BRIDGE: WEST PARAGON PARKWAY OVER LITTLE BLUE RIVER

Bridge Plans
General Plan & Elevation

3rd Party Review by HDR

DETAILS OF AESTHETIC STEEL GIRDER & ANCHORS AT END BENT & INT. BENT

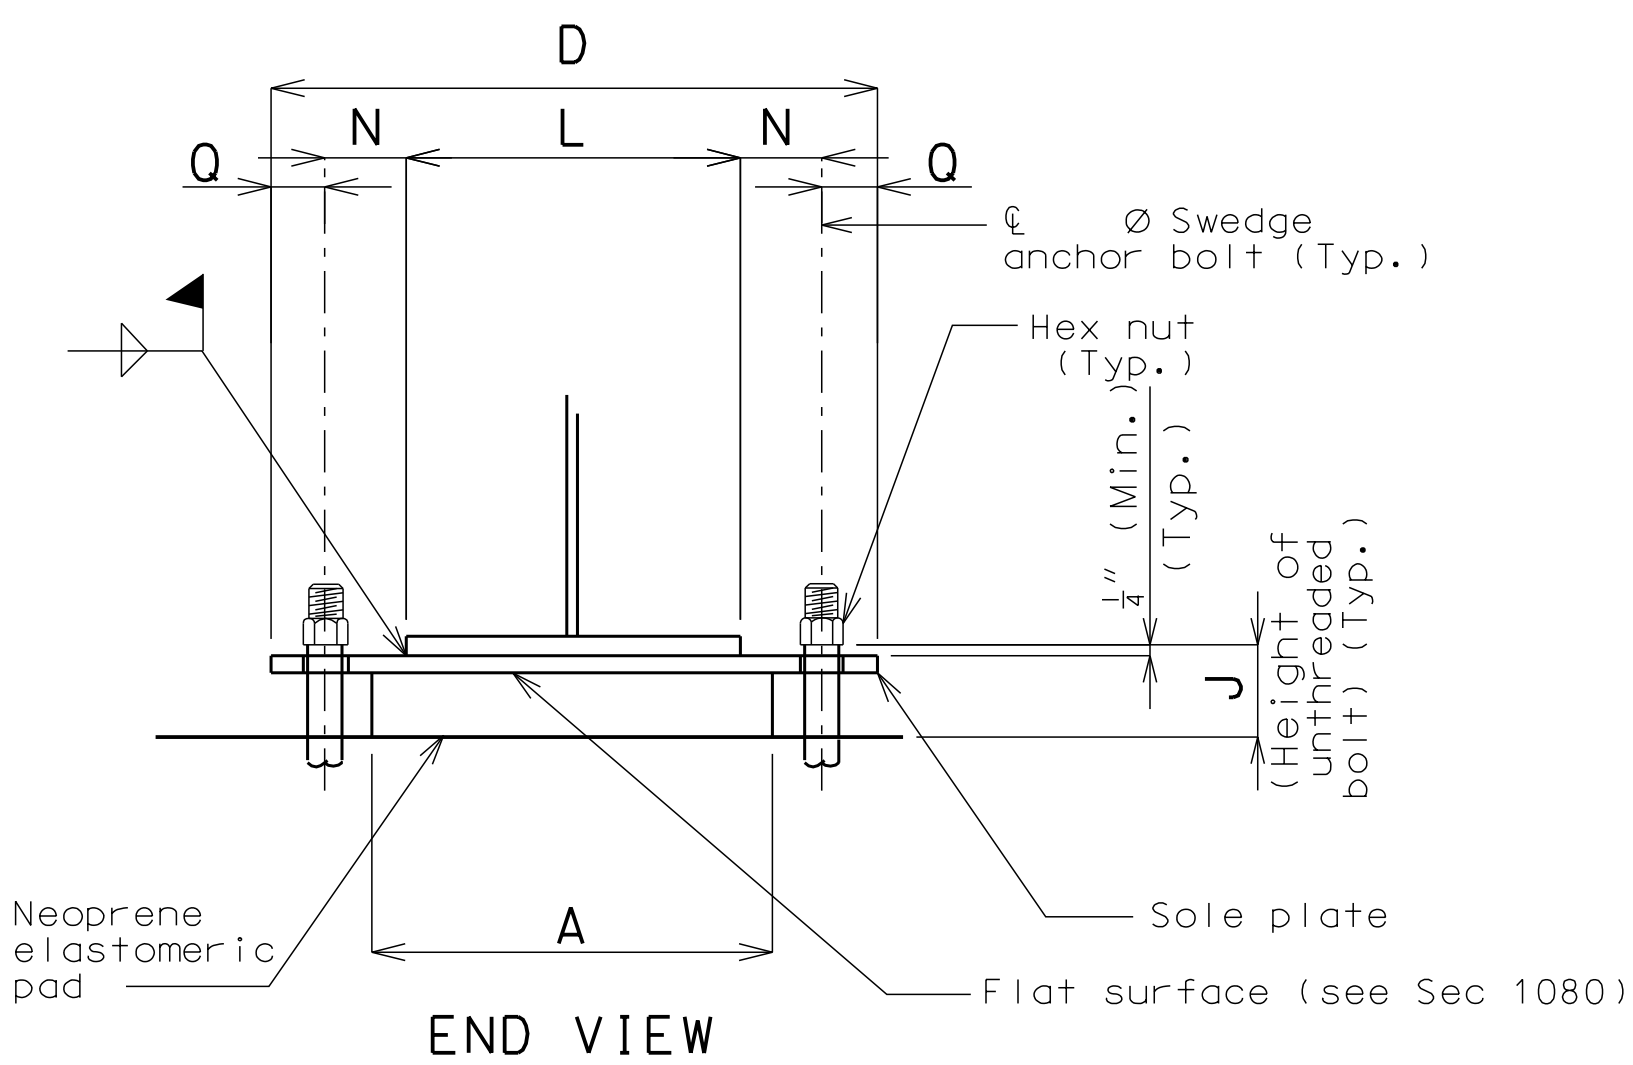
Since we are using such "stout" wall piers for Int. Bents, are expansion bearings being considered here to allow for expansion and contraction of superstructure?

[See previous response](#)
